EPA ASSESSMENT NO. 1597

**SUSSEX LOCATION 413, YALLINGUP,
SMITHS BEACH STRATEGIC
ENVIRONMENTAL ASSESSMENT
RESPONSE TO SUBMISSIONS**

Report Date: 6 October 2008
Project Ref: 2008/026, V3

Landscape Commitment Plans

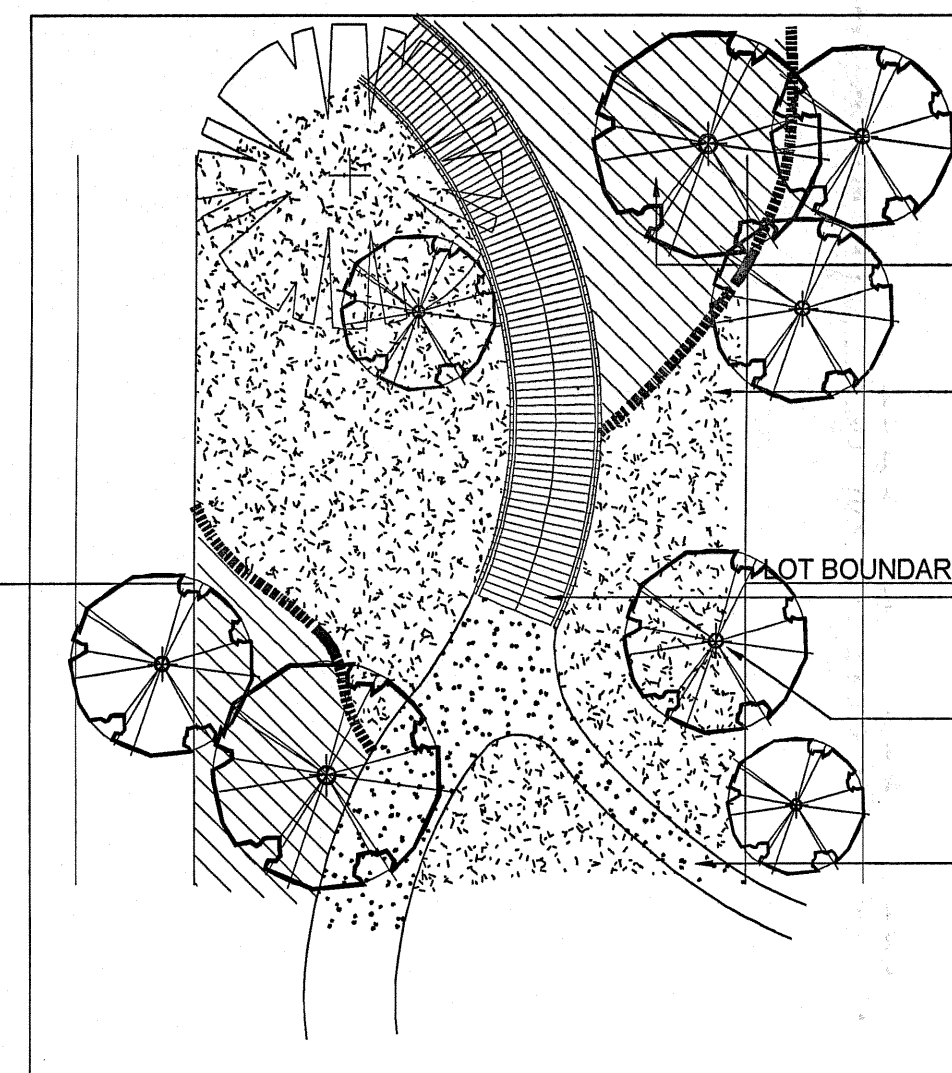
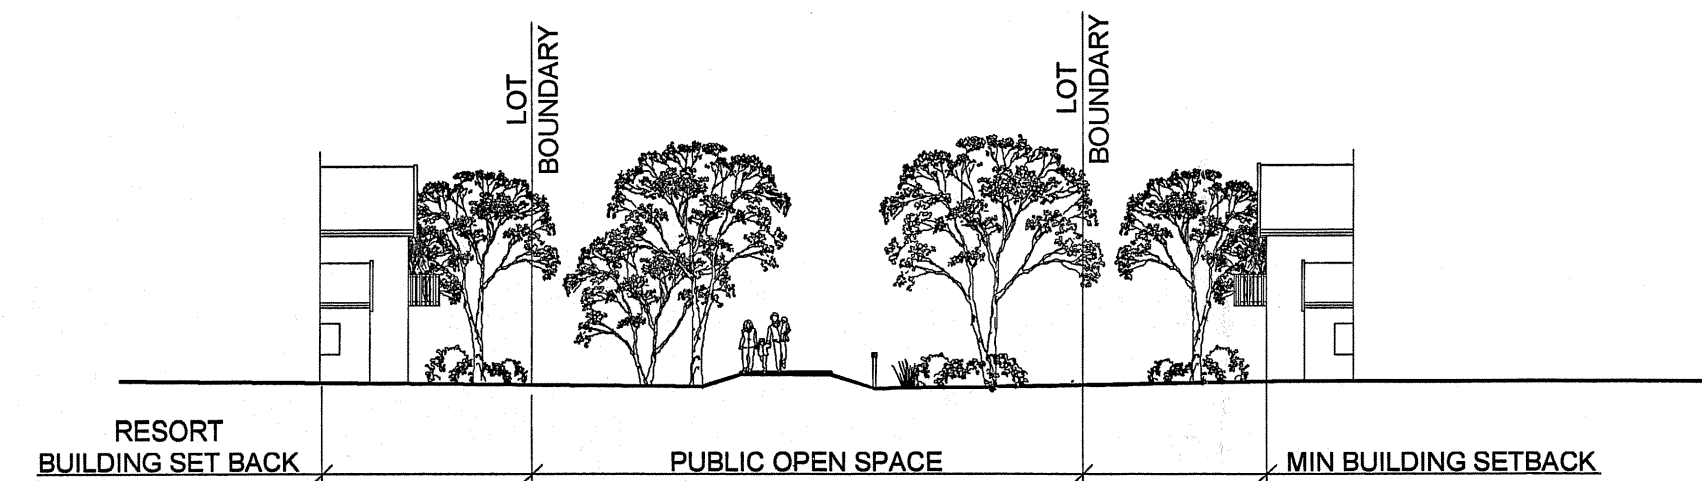
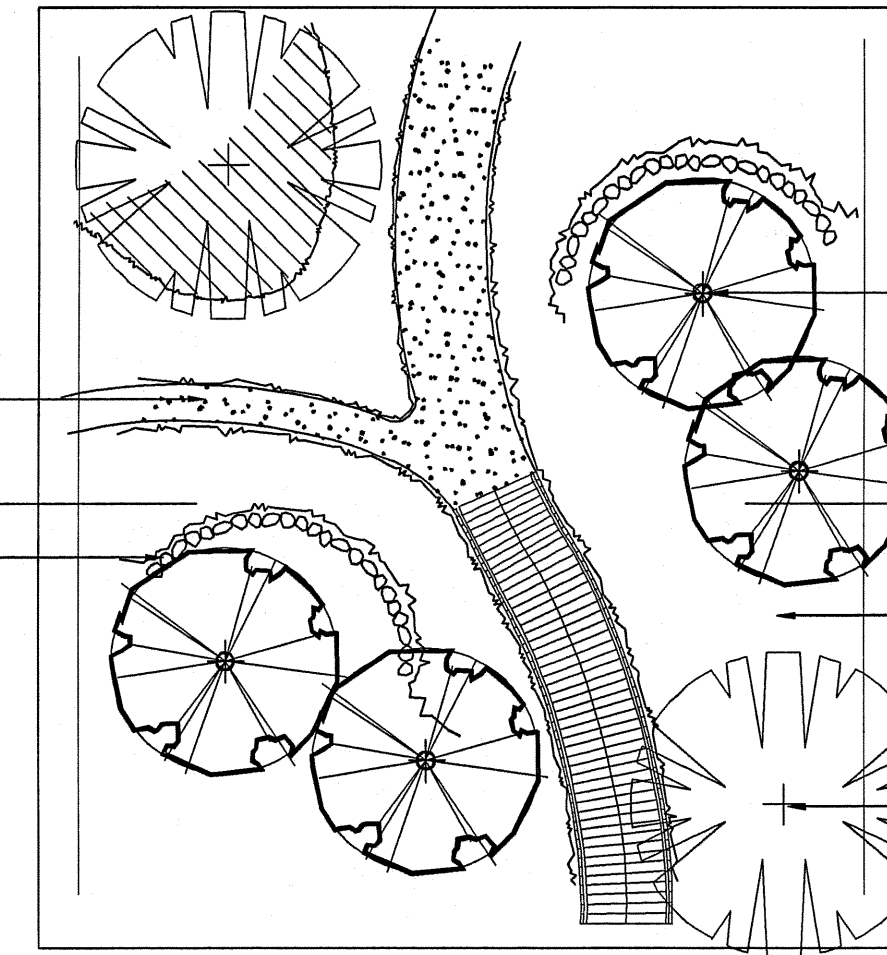
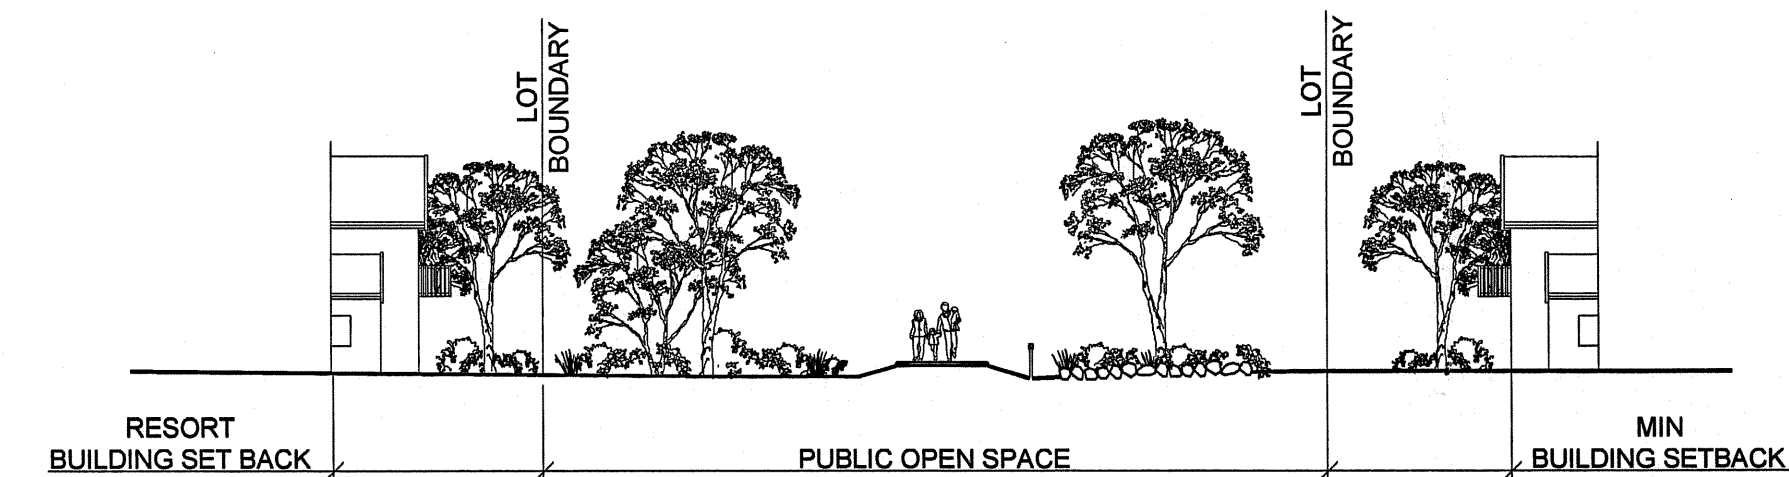
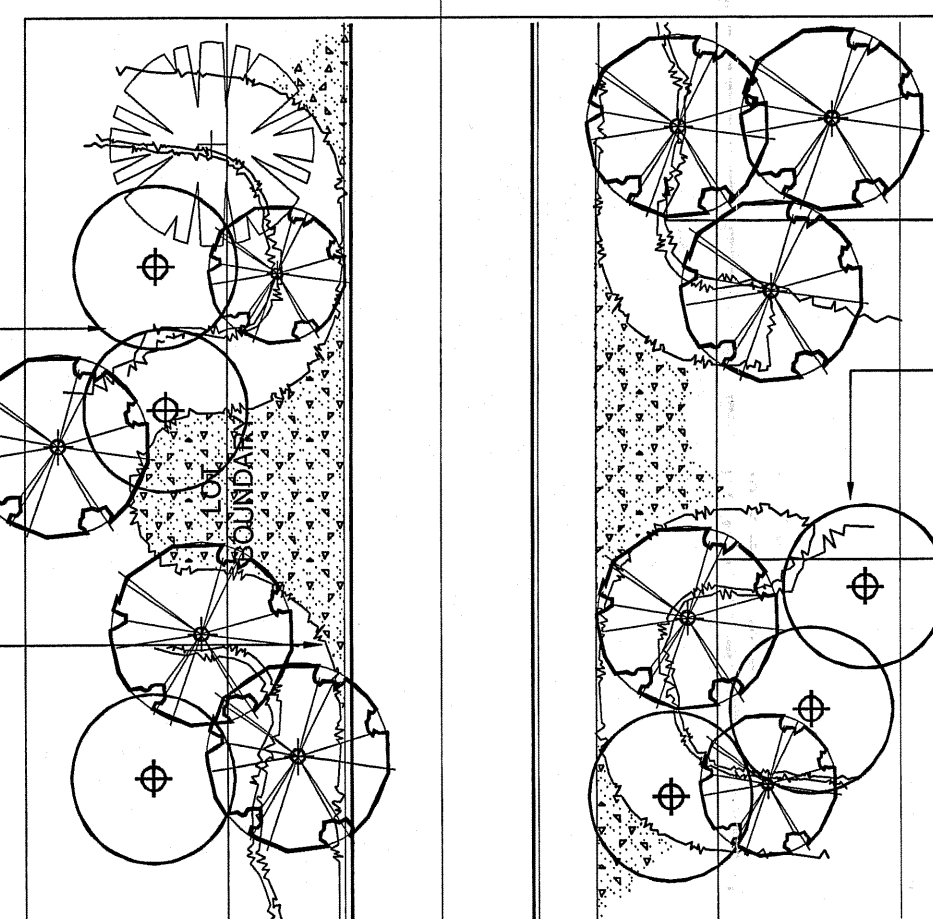
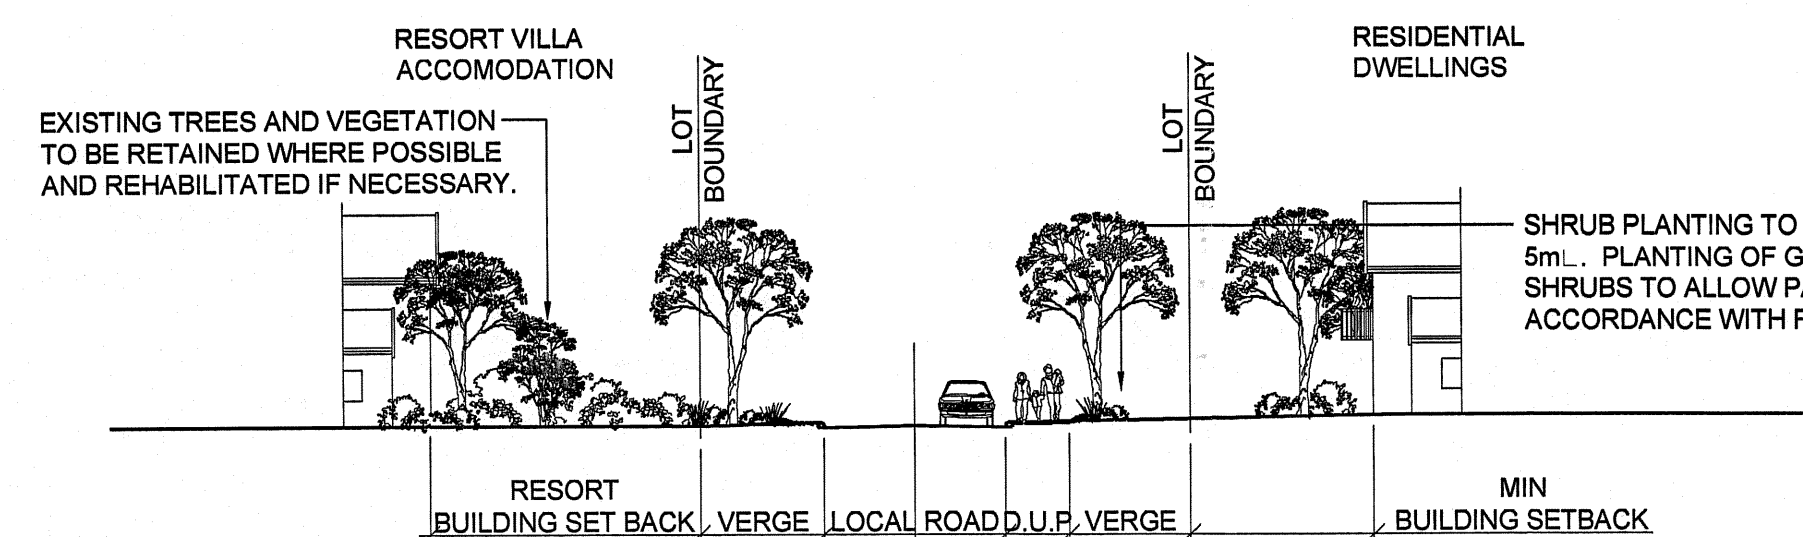
1.13. There is misrepresentation of vegetation to be retained in the development as the Fire Management Plan is in complete conflict with the vegetation retention plan. An updated vegetation plan presented as an alternative analysis (by the submitter) shows there would be extensive clearing of vegetation on the site with minimal opportunity to retain existing vegetation between buildings or replant following development.

Refer to Landscape Commitment Plans in Appendix 5 of this response for details of the anticipated final outcome with respect to tree retention and understorey species within the development. The Landscape Commitment Plans have been verified by the FirePlan WA to accurately represent the requirements of the Fire Management Plan.

The retention of trees within the development is shown on the Landscape Commitment Plans provided in Appendix 5. A substantial number of trees will be retained within the development footprint in public open space, building envelopes and road reserves.

LOCATION OF WESTERN RINGTAIL
POSSUMS AND DREYS
JANUARY 2008

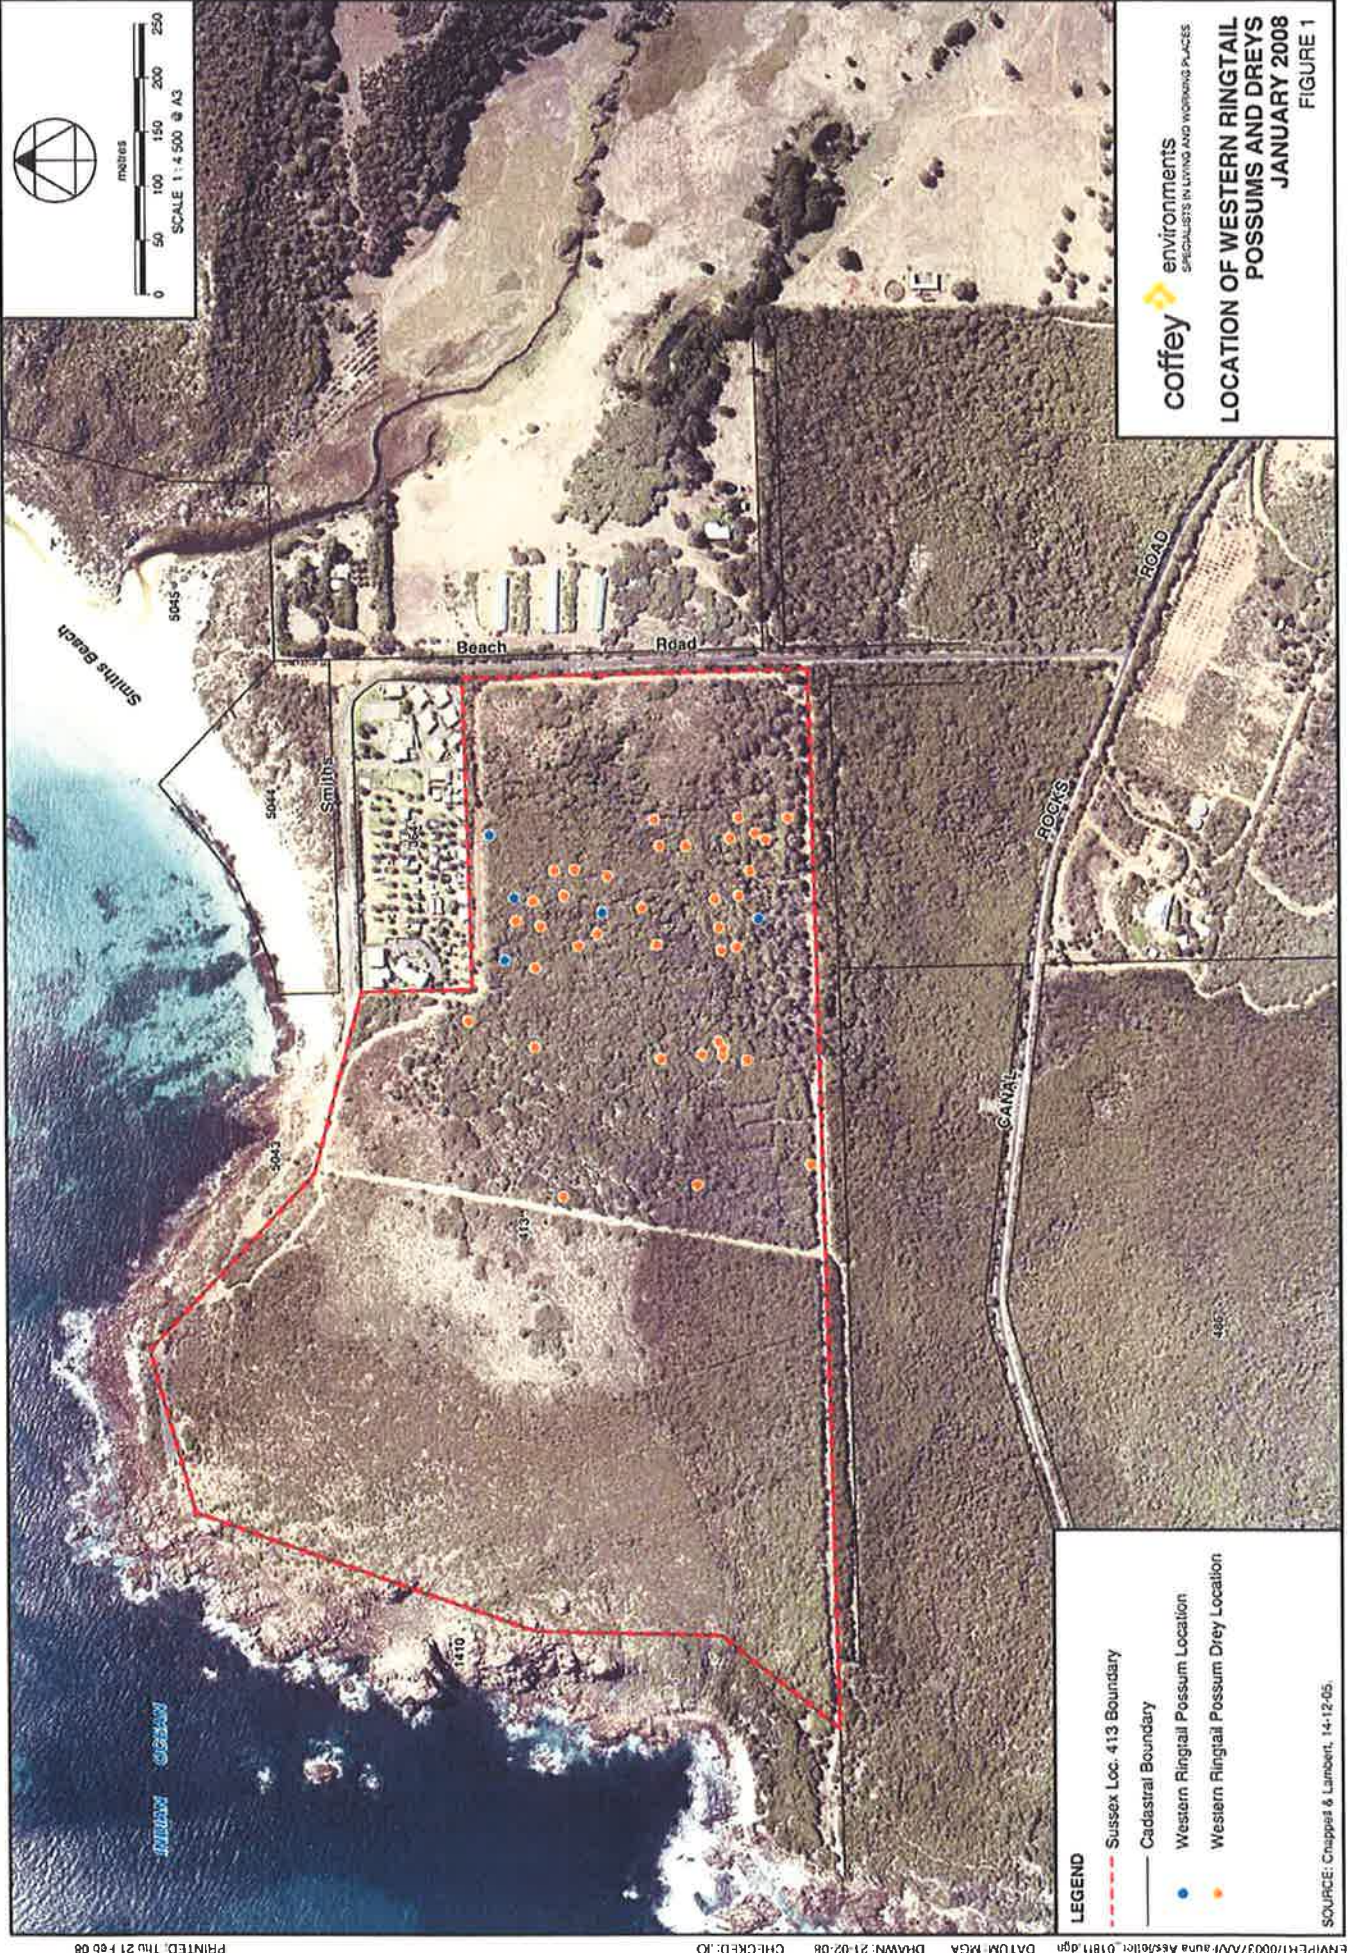
- 3.2. A survey of food plants used by Western Ringtail Possums in the project area has not been conducted. As stated in comments on the fauna report, the assumption that *Agonis* is the main food tree of this species is not correct as it is known to feed on a number of species (including *Kunzea*, *Nuytsia*, *Banksia*, *Acacia*, *Eucalyptus*) many of which are present in the study area. The reality is that the study area is likely to contain a number of food plants for this species and some of these could occur in habitats outside the areas where dreys are located.

A total of 41 possum dreys were located during the daylight search in January 2008. Locations and descriptions of each of the possum dreys are provided in Table 1 and their locations shown on Figure 1. Of these 41 dreys, six WRPs were found to be occupying a drey, resulting in a drey to possum ratio of 6.8:1.

A total of five WRPs sightings were recorded during the spotlighting survey undertaken in January 2008. Four WRPs were sighted on the first night of spotlighting and one WRP was sighted on the second night. No Common Brushtail Possums were recorded during the January 2008 survey. Table 2 shows the tree species the possums were found in and the number of possums sighted. The locations of possums sighted are shown in Figure 1.
